## IDAHO TRANSPORTATION DEPARTMENT

SUBJECT: 2023 5010-1 Airport Inspection conducted June 1, 2023.  
(04230.A Landmark Landmark USFS)

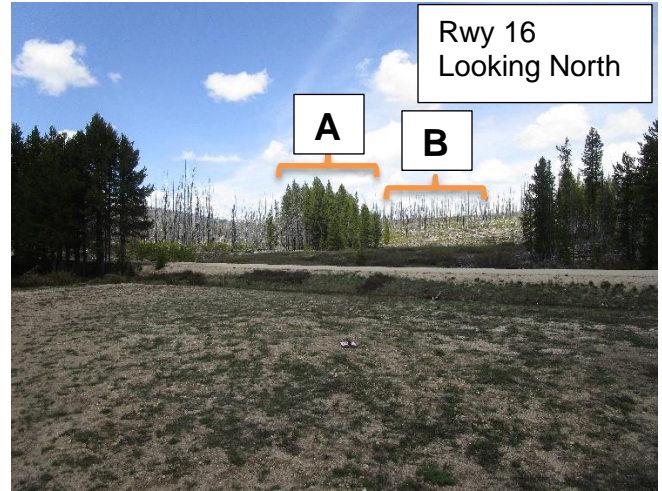
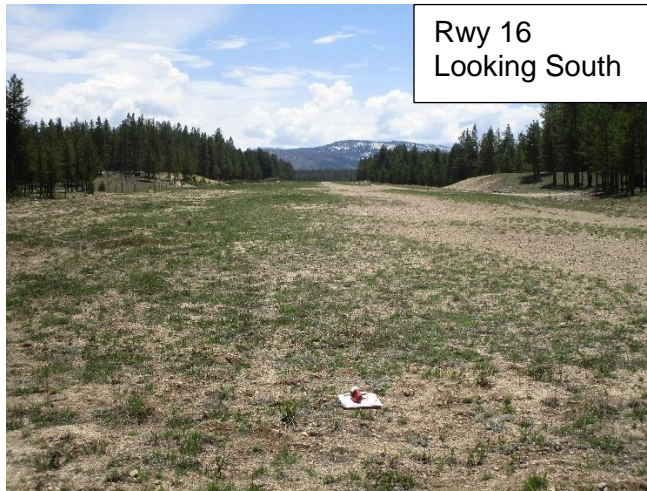
**Runway 16-34:** Overall, the runway surface remains in fair condition with some loose rocks still present in the center portion of the runway. The center 15ft portion of the runway is the area of dirt, sand, and rocks that appears to get the most use for take-offs and landings. I noticed that several areas adjacent to the center portion, on both sides of the runway, display lots of saplings - up to 20-22 inches tall, growing in the middle of the rwy. If left uncared for, these baby trees will grow and present a serious challenge down the road. A crew should investigate this and pull all those little saplings out sooner rather than later. Organizations such as IAA and RAF are always looking to help and take care of airfields on a volunteer basis...someone from your organization should reach out to them and ask for some help. The approach at rwy. end 34 is very much unchanged since last time I visited. Rwy. end 16 on the other hand, has a patch of green trees directly on extended center line (Area A) and a lot of dead trees standing on final approach, still (Area B). All efforts to knock down as many of those trees, starting with the ones closest to the runway end would be tremendously helpful in providing a safe passage for both arriving and departing aircraft. There were no changes to the approaches at this airport; both remain relatively unchanged since the last inspection.

1. Remove the many saplings growing on the runway,
2. If possible, remove as many of the dead snags located on final approach to Rwy. 16 (Area B), and the tallest of green trees closest to the rwy., on rwy. extended center line (Area A).
